IEC/IEEE 60802

IA-station Model

V02 – November 2021

IA-controllers and IA-devices in IA-stations

60802 D1.3 IA-station model

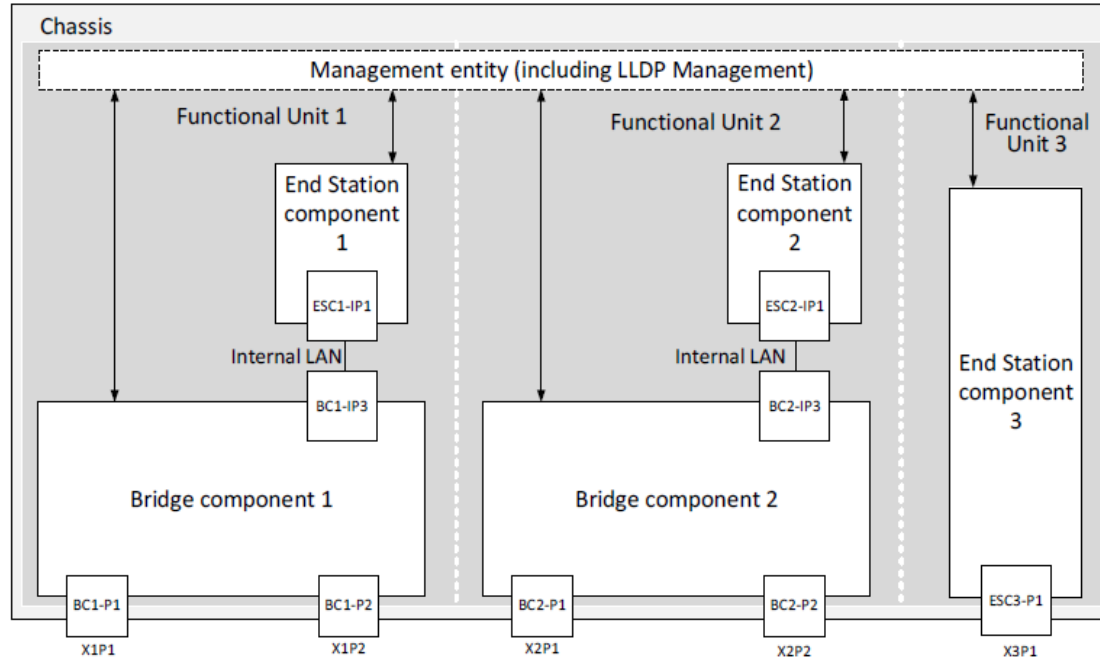
- The relation between IA-stations and IA-controllers / IA-devices is not described in D1.3 – only a Note indicates:
Note 1 to entry: IA-controllers and IA-devices contain an IA-station
- The IA-station example in D1.3 (Figure 2) shows only a management view - without any IA-controller / IA-device instance.

→ This led to confusion and discussions!

See D1.3 comments #127 and #140:

the relationship between **IA-stations** and **IA-controllers / IA-devices** should be described

Management in IA-stations

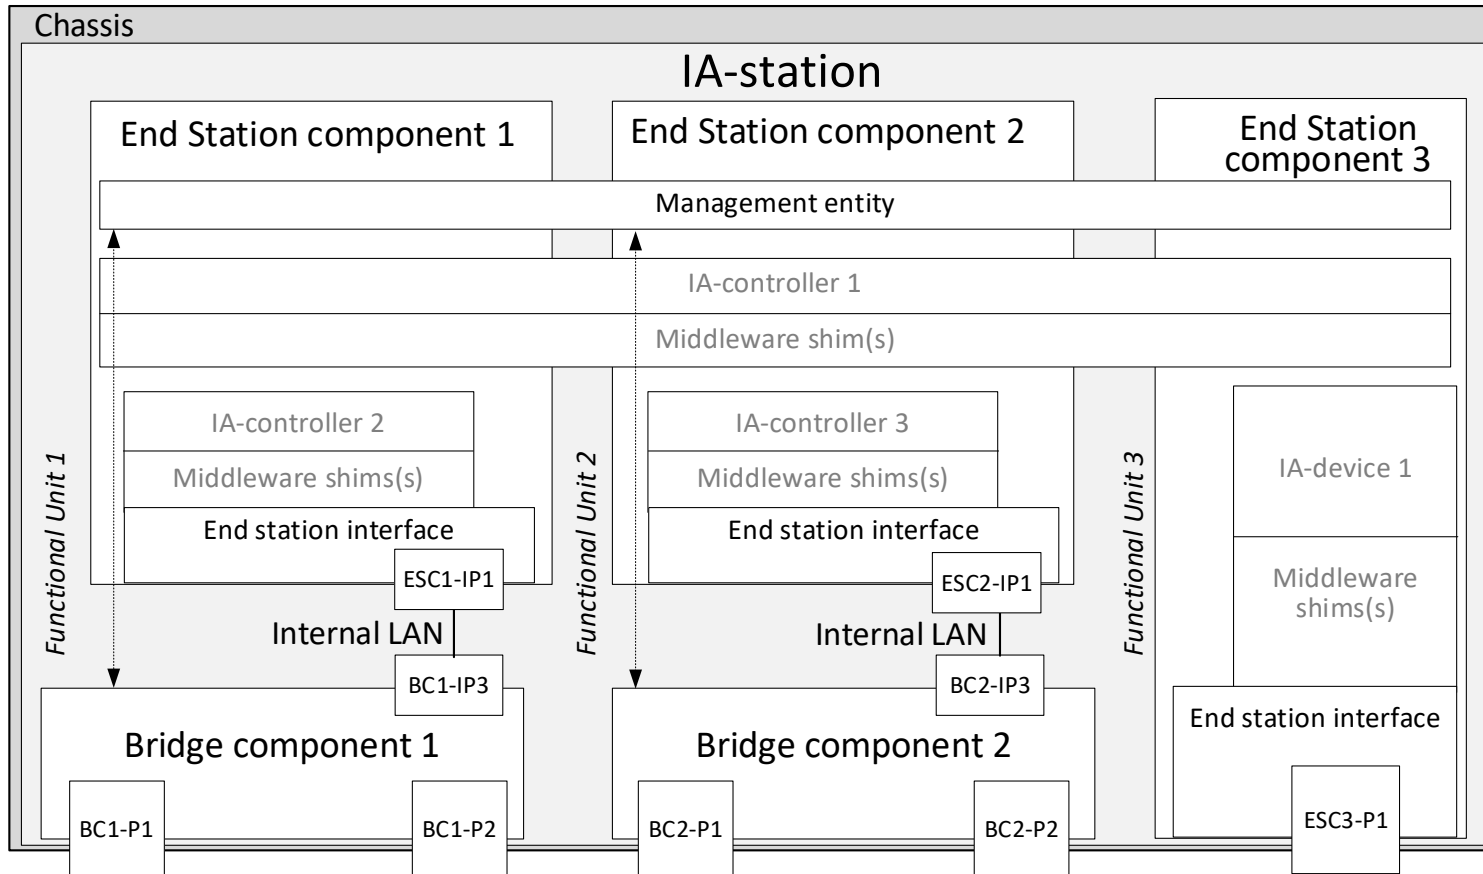
- Management entity acts as “*a source of, and/or destination for, link layer data traffic carried on the network*” (see IEEE 802-2014).
 - **Management entity is an end station.**

Proposal for enhanced Figure 2 (aligned to Figure 3 – Industrial Application)

- IA-station applications can
 - be assigned to a single end station component, or
 - encompass multiple end station components.
- Management entity is an IA-station application encompassing all end station components.
- IA-controller/-device and middleware shim(s) are out-of-scope for IEC/IEEE 60802.
